Project Name: DeRiso Addition

Street Address: 10 Iroquois Ave  
Palisades

Project Description: (If additional space required, please attach a narrative summary.)  
Single story addition & front porch

**REFERRAL TO THE ZONING BOARD OF APPEALS**

SITE PLAN, ZONING, EXIST FL PLAN

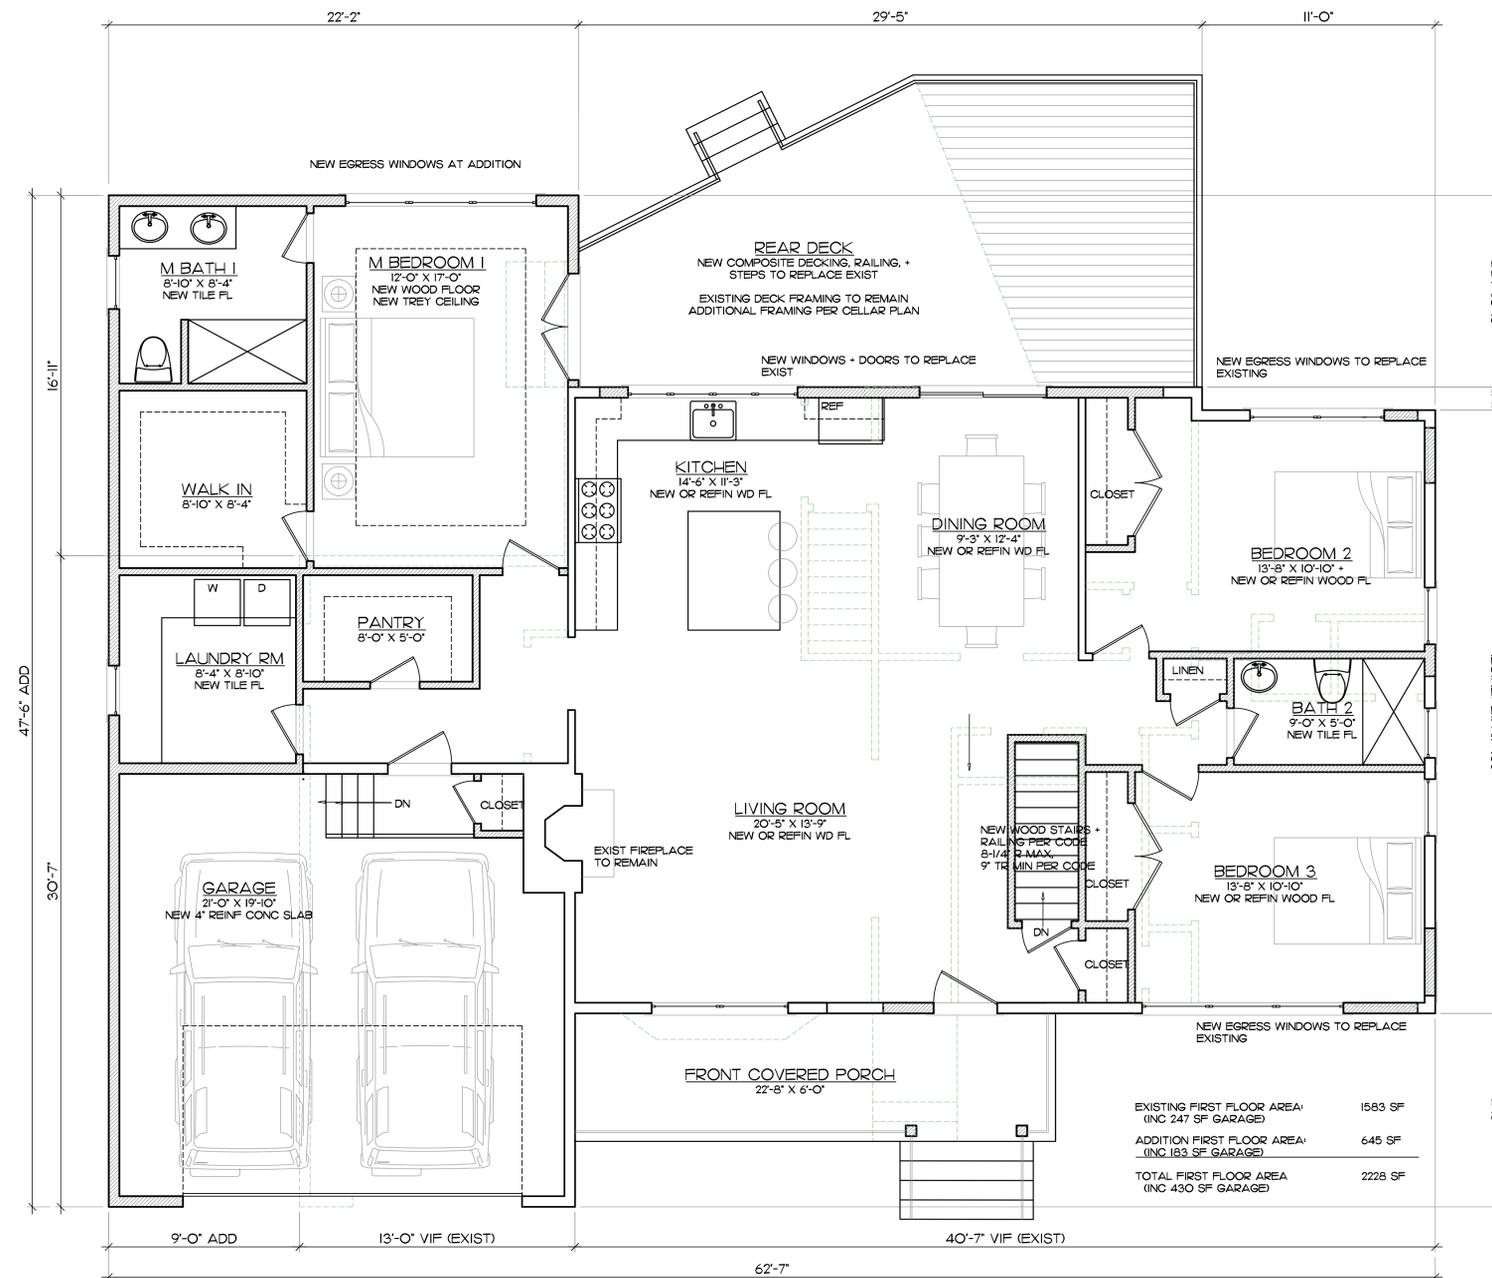
Chapter 43, Section 3.12 R-15 M  
Col 10 Total side yard 50' required / 40.8 proposed,

One variance needed
